### APPEAL SUMMARY

**Appeal ID:** 20398

**Project Address:** 1417 NW 20th Ave

**Building/Business Name:** Saltwood North

Appendix A; Figure 1: Floor Plan Showing the Location of Mineral Wool Filled Exterior Walls

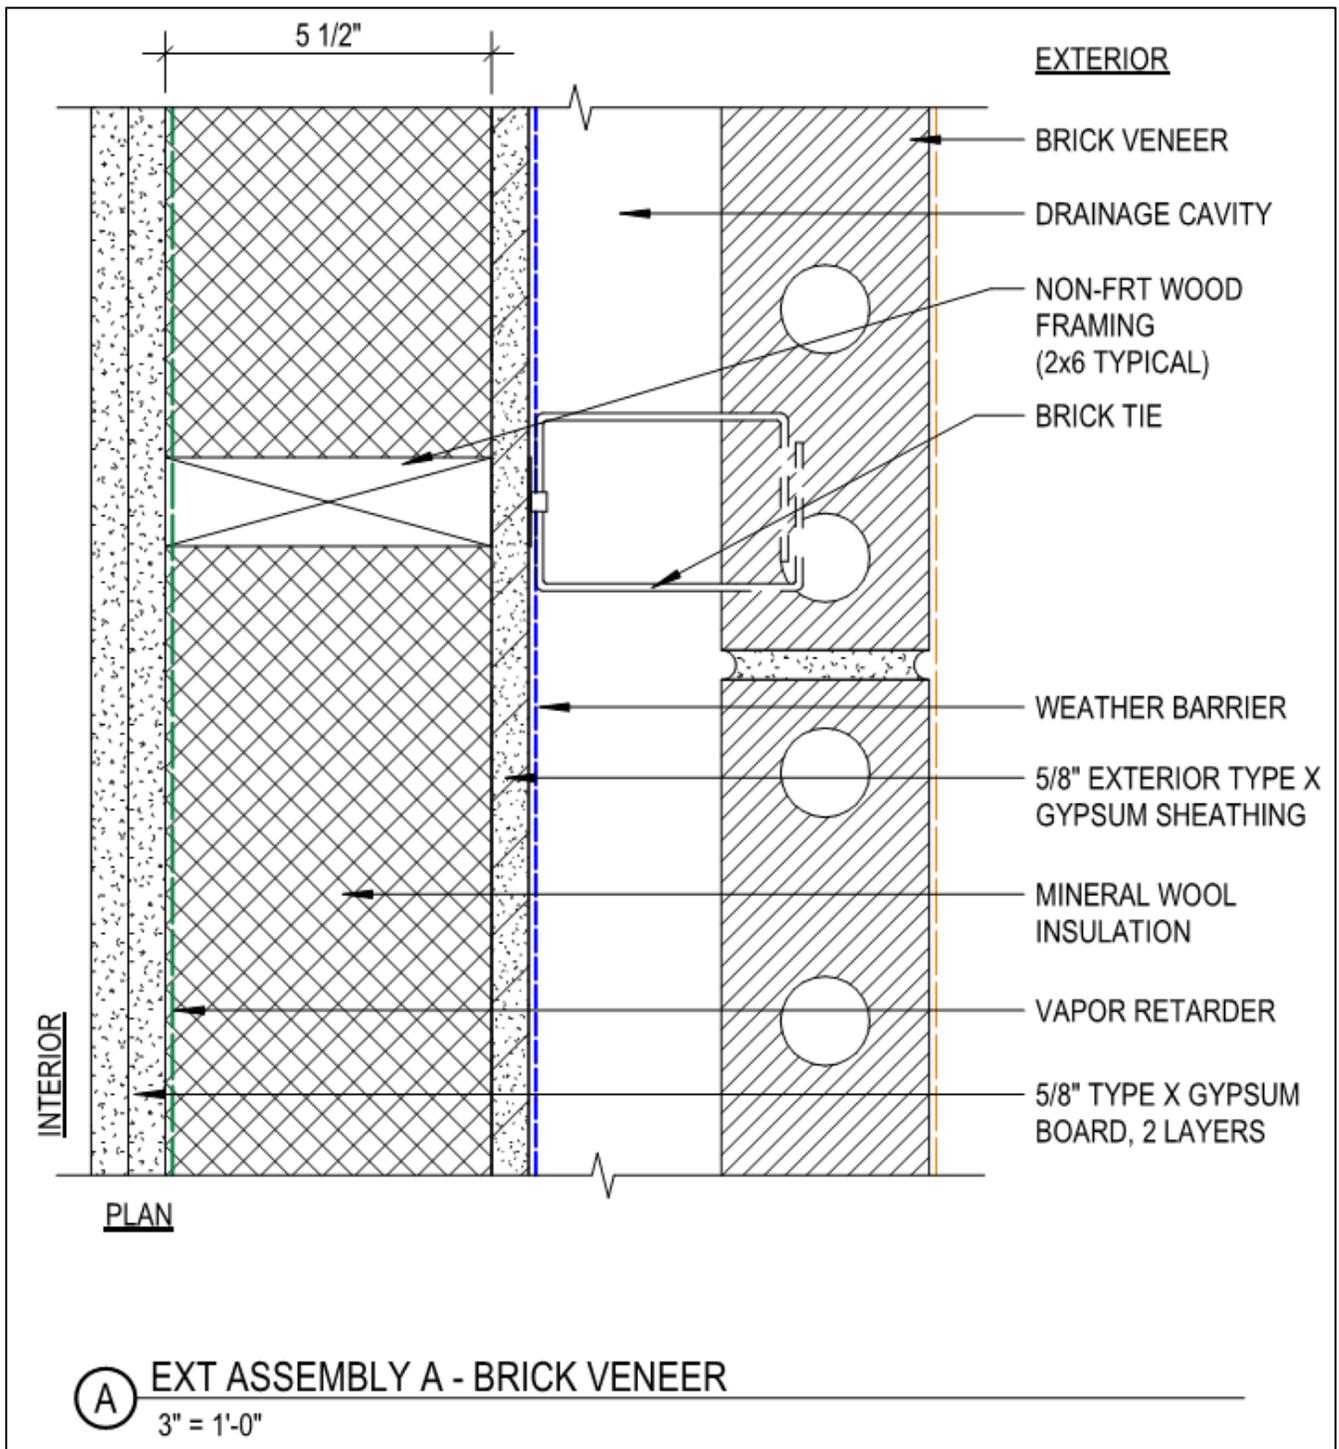
For condition #17. All framing details (0-19) will be followed, with the exception that sacrificial studs will not be provided. Exterior street facing walls will be protected with non-combustible mineral wool insulation as detailed in the typical wall assemblies shown in Appendix A of the attached report. Mineral wool insulation will be provided in exterior walls in lieu of fire-resistant treated wood stud framing.

The addition of protection of all street facing exterior walls with mineral wool filled stud cavities provides a fire-resistance rating exceeding the OSSC required minimum, resulting in a higher level of building safety.

**Use of non-fire-resistant studs in exterior walls of Type III construction: Granted provided a Special Inspection is provided for mineral wool installation and provided mineral wool is installed in all exterior walls.**
